#892A-1

Enclosed is the building permit covering erection of one outside brick chimney for Fred Foley in the filling station building at the corner of Voranda Street and Washington Avenue.

Referring to your application for a building permit to erect a 3 story brick store and tenement building at 515-519 Washington Avenue, the following details must be taken care of on the plan before the permit may be issued:

PLAN OF PLOT OF LAND AT CORNER OF  
 WASHINGTON AVE. & URBAN STREET  
 SHOWING PROPOSED LOCATION OF BUILDINGS.  
 Ansel E. Hadden, Owner  
 Oscar Emerson, Architect.

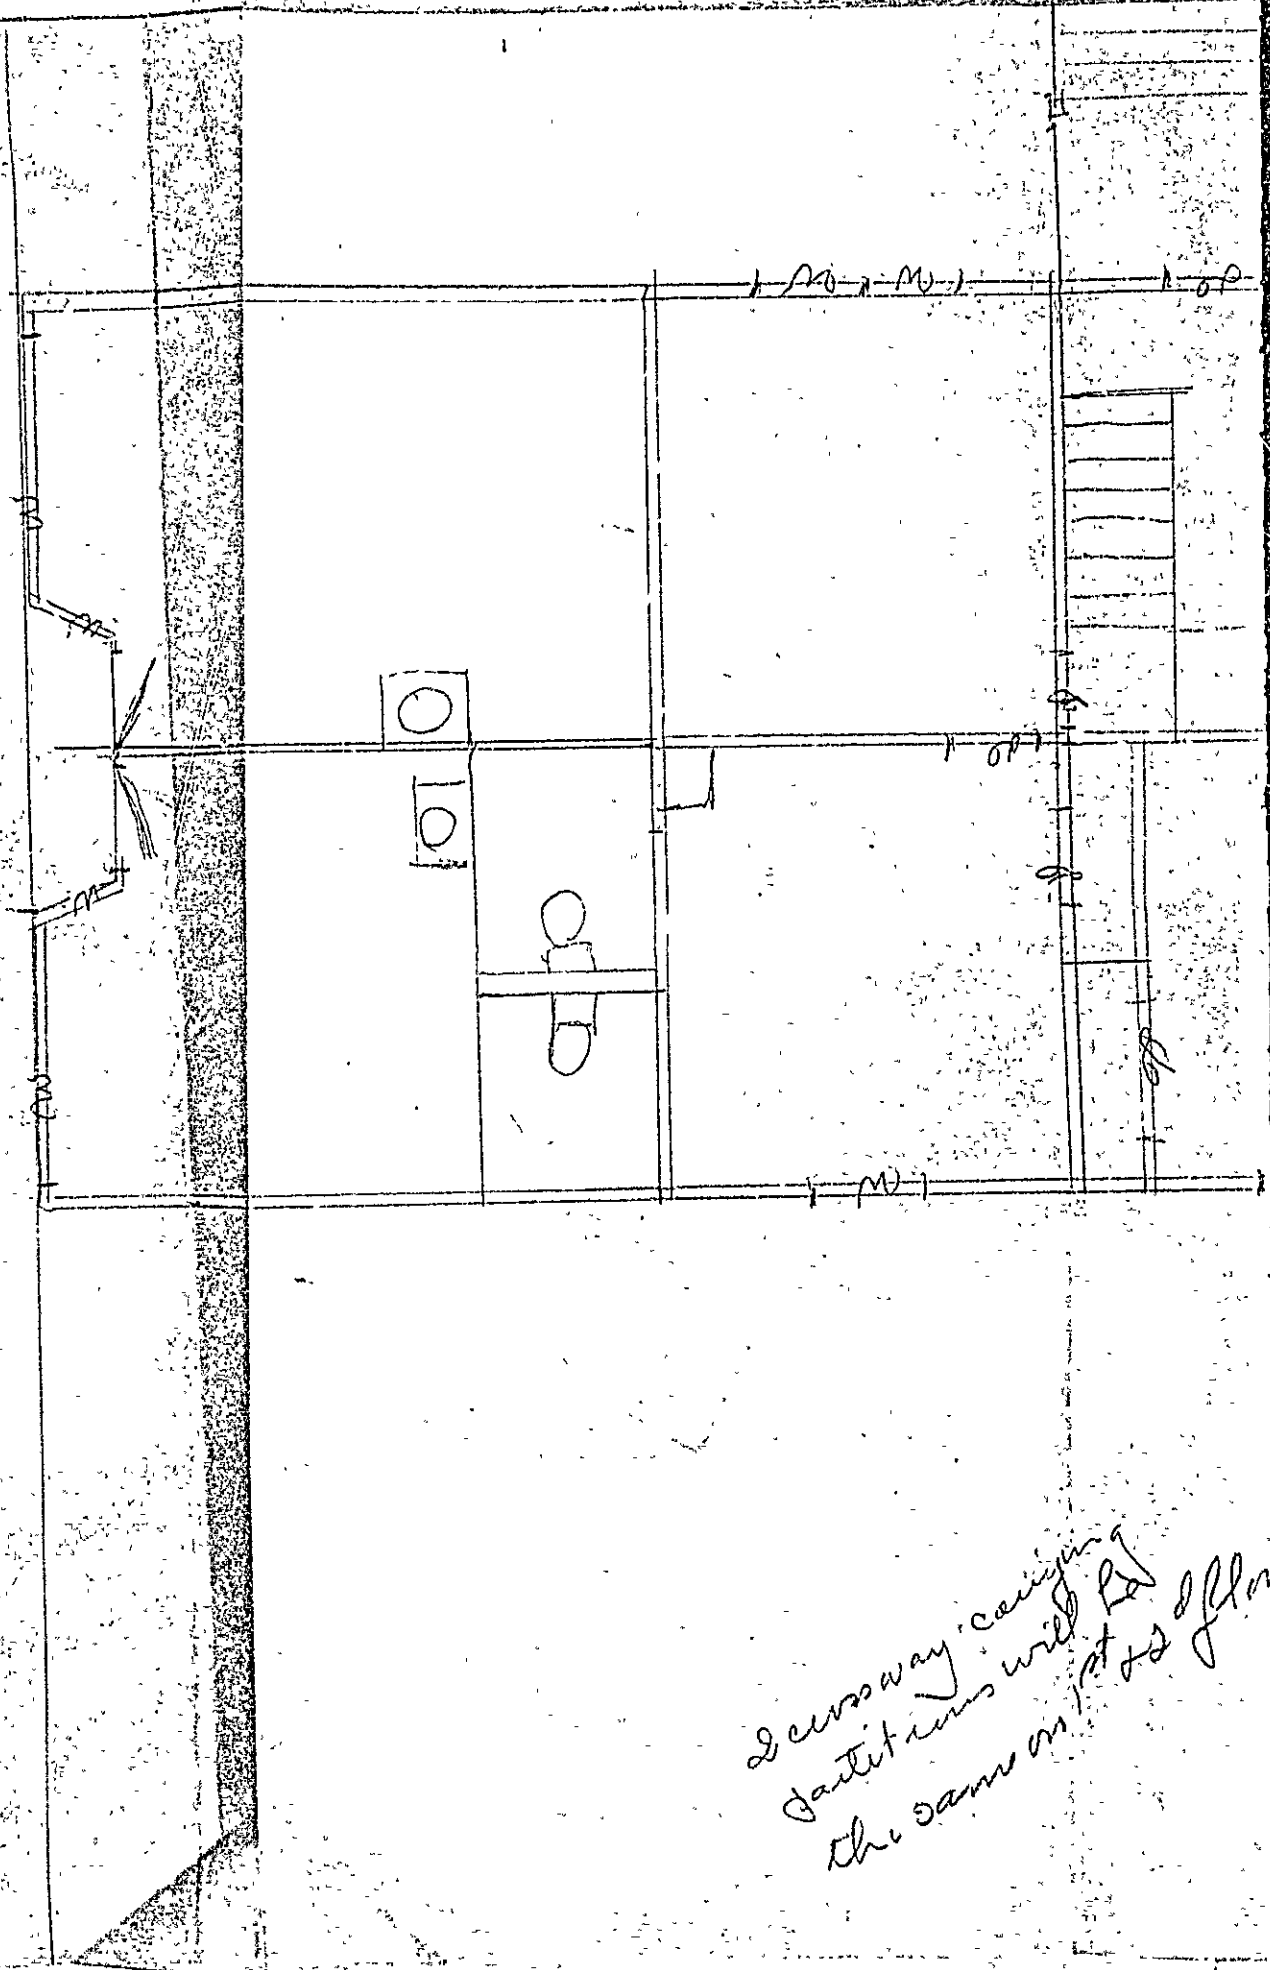
P.S. In addition to the above, the wall of the garage which is shown 4 feet from the future A & P store should be an unpierced masonry wall at least 8 inches in thickness also.

There seems to be a question as to whether you have any right in the alley adjoining your property. If you have right in at least one-half of the alley, this building may be moved up to the line of the alley. If you have no right in the alley, the law requires that the side wall of the building must be located at least five feet from the line of the alley, this being under such circumstances your lot line.
